## **A-6348 (a, b & c) (Retroactive Variance Request)**

CHEVY CHASE VILLAGE  
BOARD OF MANAGERS  
JUNE 10, 2013 MEETING

STAFF INFORMATION REPORT

**TO:** BOARD OF MANAGERS  
**FROM:** ELLEN SANDS, PERMITTING AND CODE ENFORCEMENT COORDINATOR  
**DATE:** 6/6/2013  
**SUBJECT:** HEARING OF APPEAL CASE NO. A-6348 RETROACTIVE VARIANCE REQUEST  
TIFFANY AND DANIEL SANDERS, 5610 KIRKSIDE DRIVE  
TO MAINTAIN A NEWLY INSTALLED FENCE WITH:  
A) A PAIR OF GATES THAT MEASURES A MAXIMUM OF FOUR FEET, TEN INCHES (4'-10") IN HEIGHT IN THE MONTGOMERY STREET FRONT YARD;  
B) A GATE THAT MEASURES A MAXIMUM OF FOUR FEET, SIX INCHES (4'-6") IN HEIGHT IN THE KIRKSIDE DRIVE FRONT YARD; AND  
C) A FENCE POST THAT MEASURES A MAXIMUM OF FOUR FEET, FIVE INCHES (4'-5") IN HEIGHT IN THE KIRKSIDE DRIVE FRONT YARD.

Figure 1: View of the pair of gates in the Montgomery Street front yard.

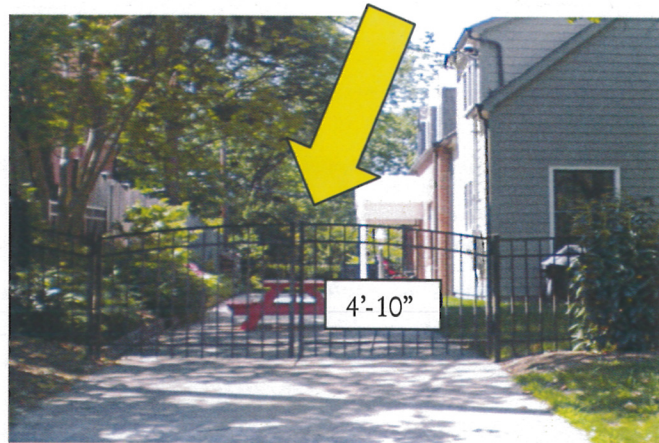
While on routine Code enforcement patrol, staff noted that the fence had been installed and that portions of it appeared taller than allowed in the Montgomery Street and Kirkside Drive front yards. Staff determined there were three (3) locations where the fence exceeded the allowable height of four (4) feet for a fence in a front yard: (a) at the driveway gates; (b) at the gate in the Kirkside Drive front yard; and (c) at the post at the northeast corner of the fence.

I move to direct staff to draft a decision **APPROVING/DENYING** the variance request to maintain a) a pair of gates that measures a maximum of four feet, ten inches (4'-10") in height in the Montgomery Street front yard in Case A-6348 (a), based on the findings that ...

Figure 2: View of gate in the Kirkside Drive front yard.

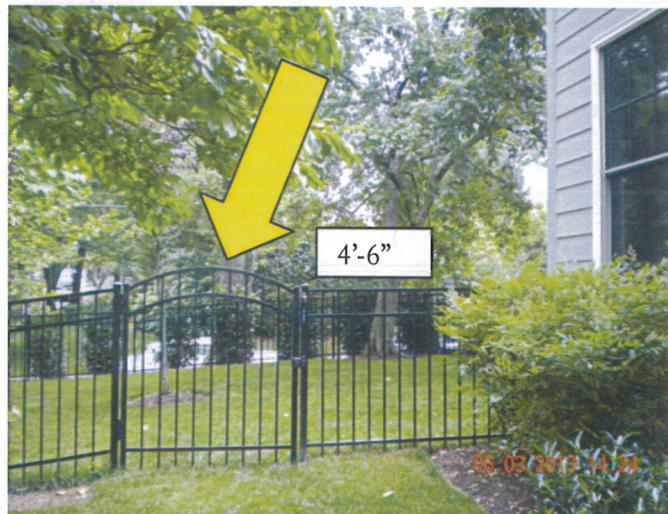
I move to direct staff to draft a decision **APPROVING/DENYING** the variance request to maintain b) a gate that measures a maximum of four feet, six inches (4'-6") in height in the Kirkside Drive front yard in Case A-6348 (b), based on the findings that ...

Figure 3: View of the fence post in the Kirkside Drive front yard.

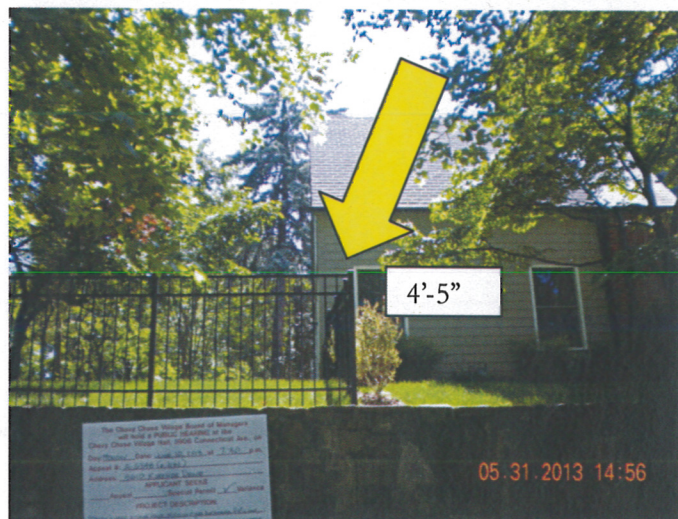
I move to direct staff to draft a decision **APPROVING/DENYING** the variance request to maintain c) a fence post that measures a maximum of four feet, five inches (4'-5") in height in the Kirkside Drive front yard in Case A-6348 (c), based on the findings that ...
